Addendum No: 02

Project: Davis Elementary School, LUSD

Issue Date: 08/04/2026

PBK Project No: 230217 / DSA # 02-123250

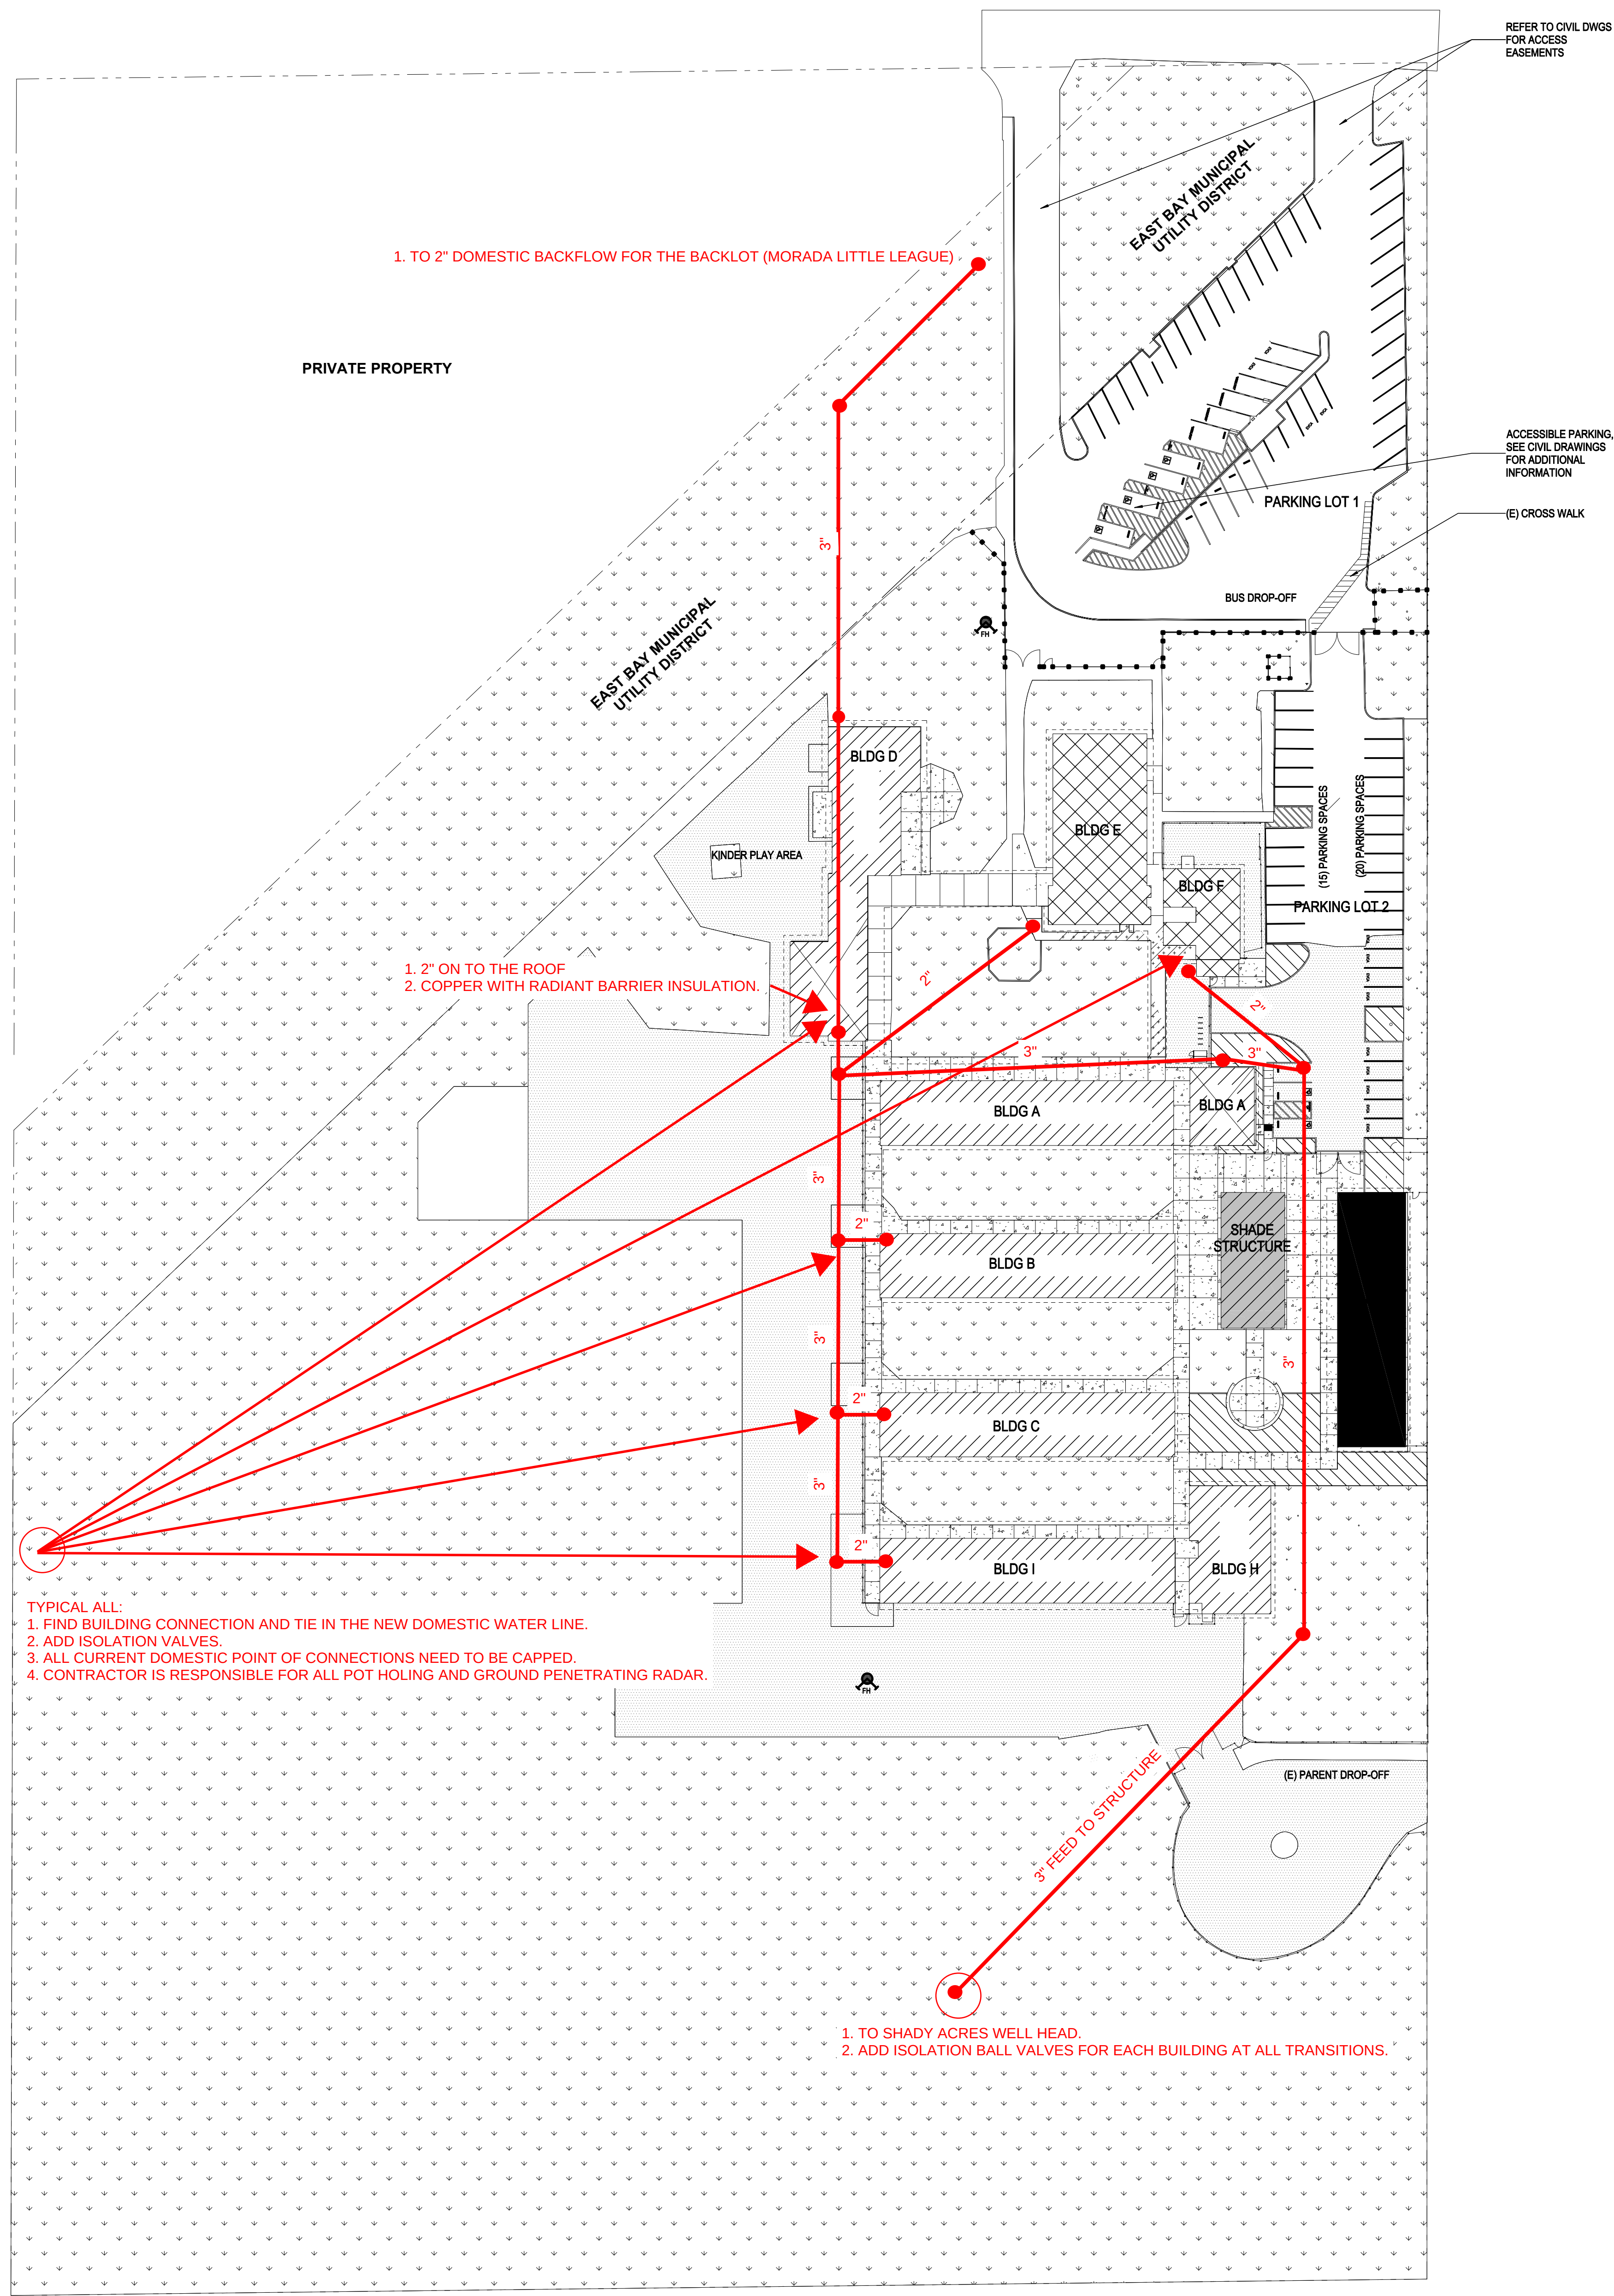
- Item 16. Replace sheet E6.03 – Electrical Schedules with the attached sheet showing updated Panel AC6 Main.
- Item 17. Add sheet U1.01 – Water Utility Plan Add Alternate #1, provided by District, for new water line to existing buildings on campus.

TYPICAL ALL:
1. FIND BUILDING CONNECTION AND TIE IN THE NEW DOMESTIC WATER LINE.
2. ADD ISOLATION VALVES.
3. ALL CURRENT DOMESTIC POINT OF CONNECTIONS NEED TO BE CAPPED.
4. CONTRACTOR IS RESPONSIBLE FOR ALL POT HOLING AND GROUND PENETRATING RADAR.

GENERAL NOTES:
1. ADD ALTERNATE #1
2. FIRE AND IRRIGATION TO STAY IN PLACE AND FUNCTION WITH THE EXISTING WELL WATER SYSTEM

U1.02

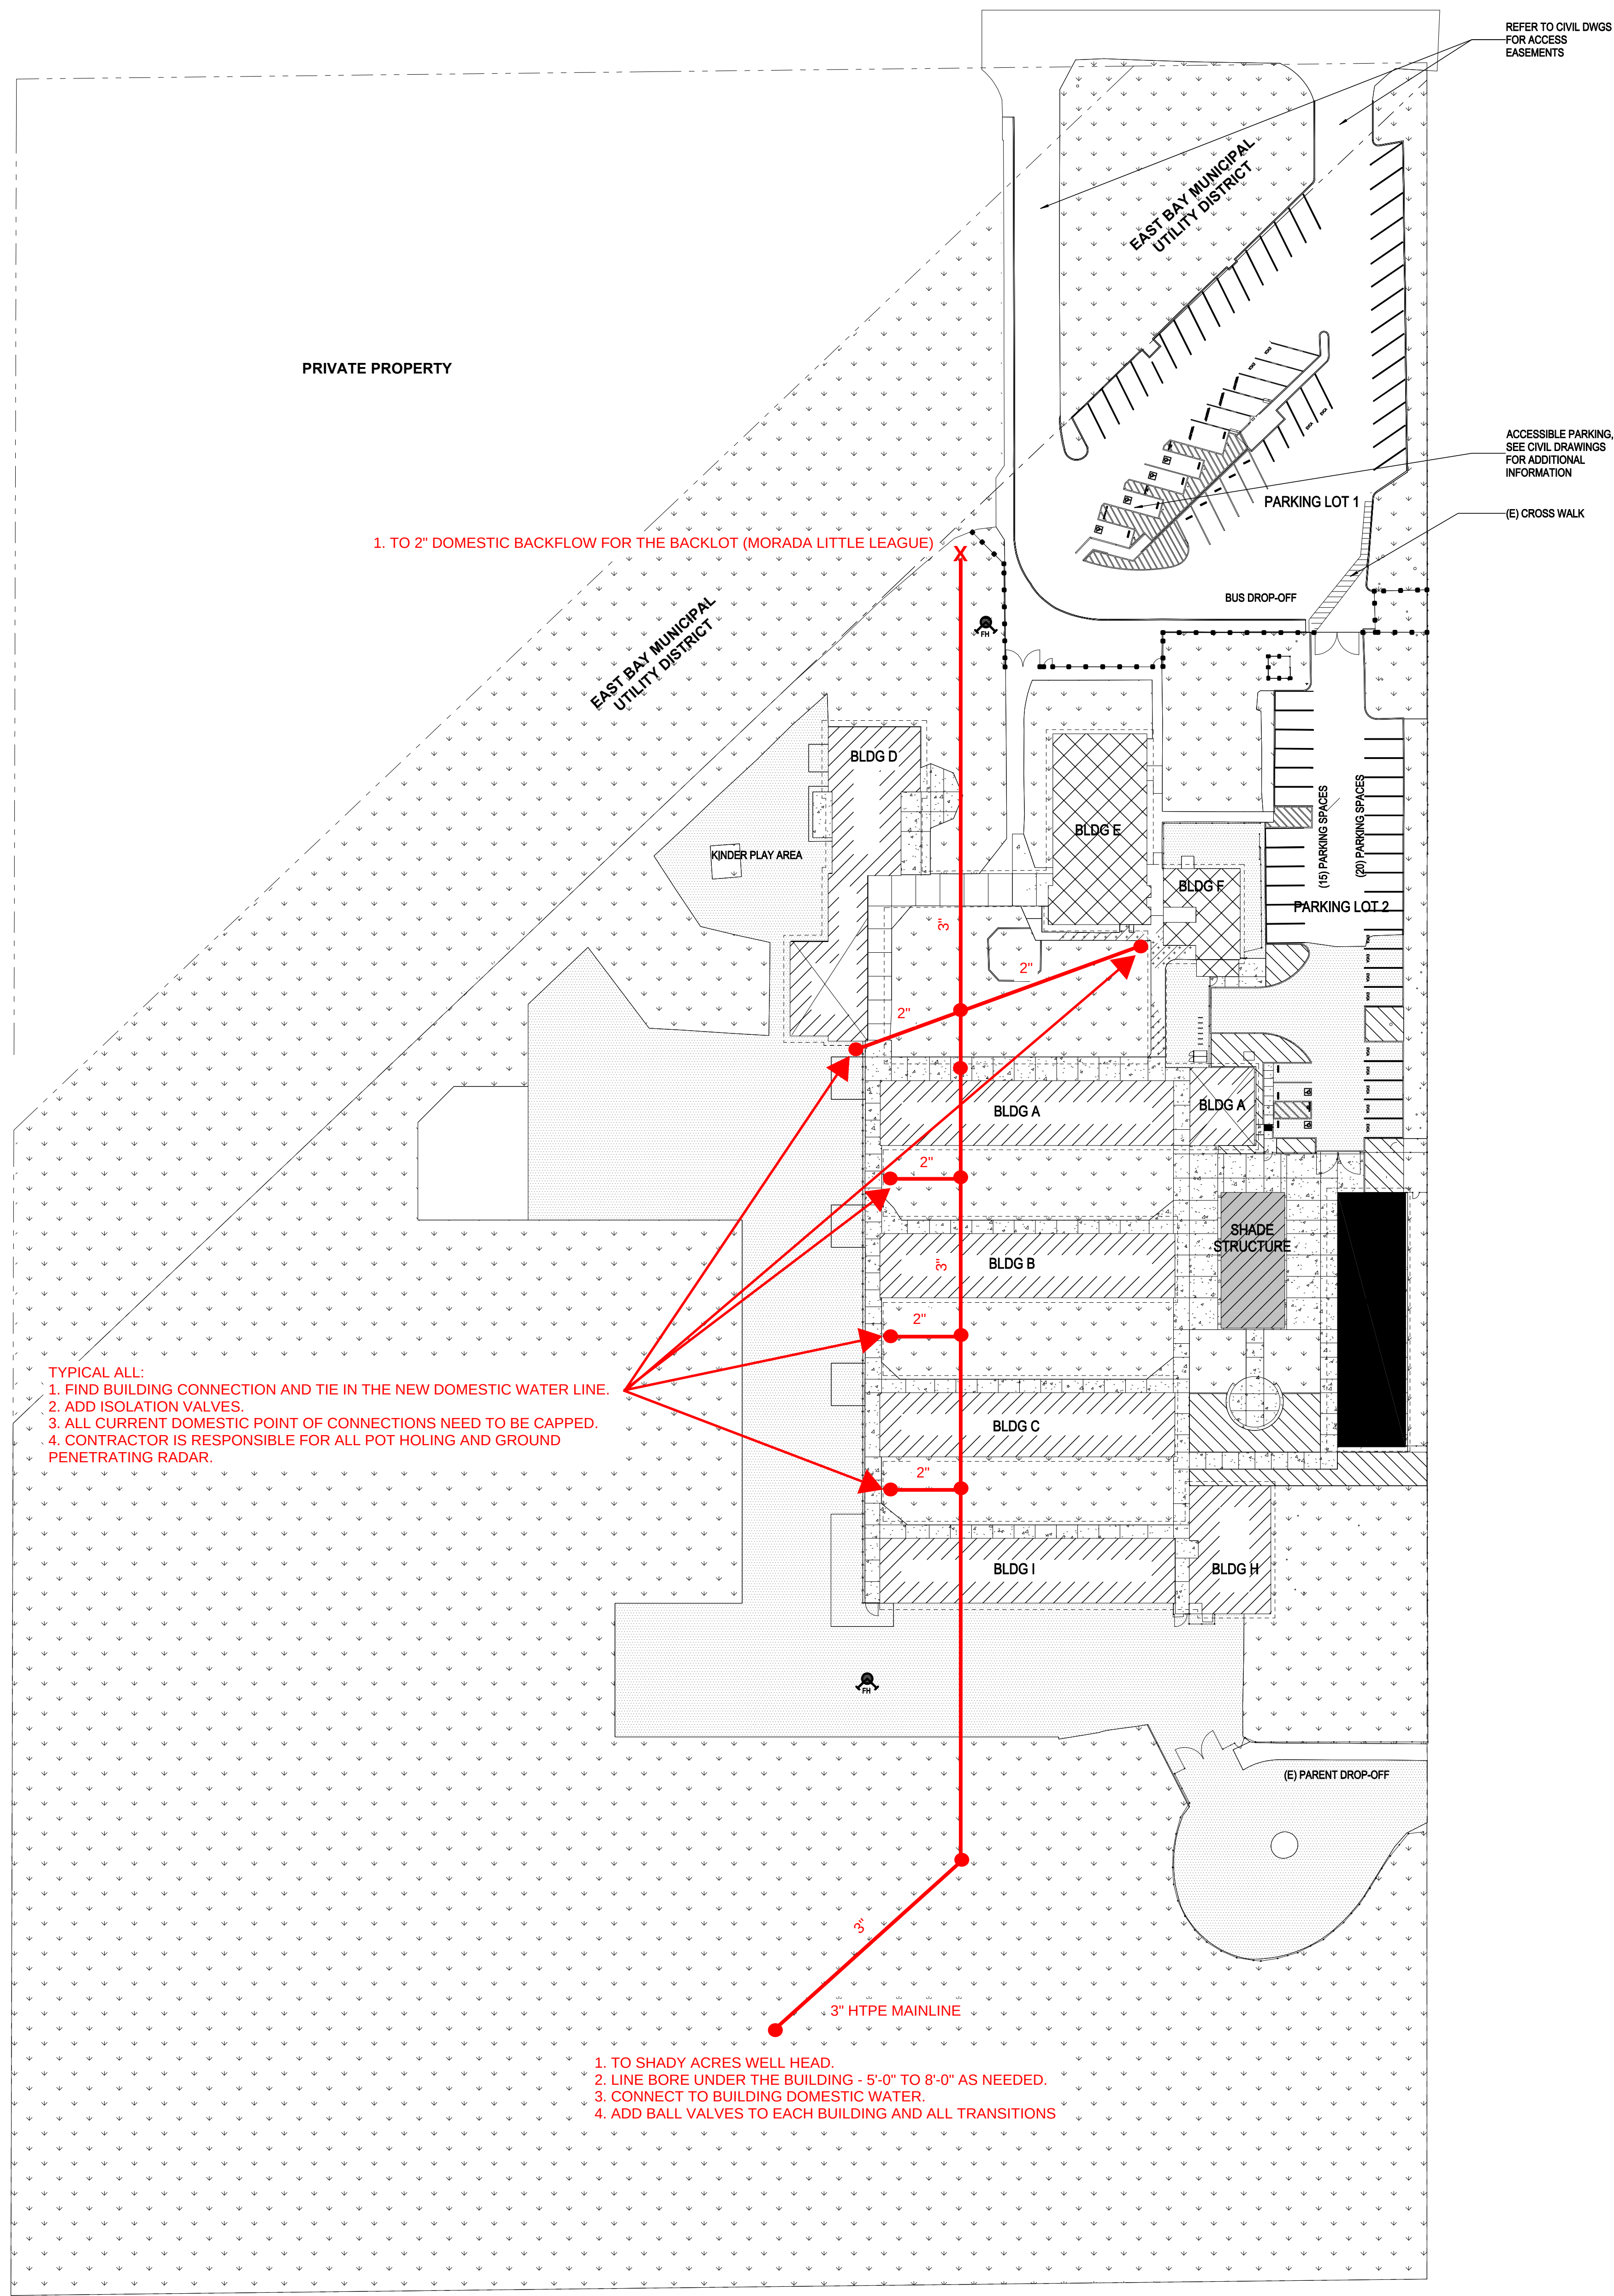
- Item 18. Add sheet U1.02 – Water Utility Plan Add Alternate #2, provided by District, for new water line to existing buildings on campus.

GENERAL NOTES:
1. ADD ALTERNATE #2
2. FIRE AND IRRIGATION TO
STAY IN PLACE AND FUNCTION
WITH THE EXISTING WELL
WATER SYSTEM
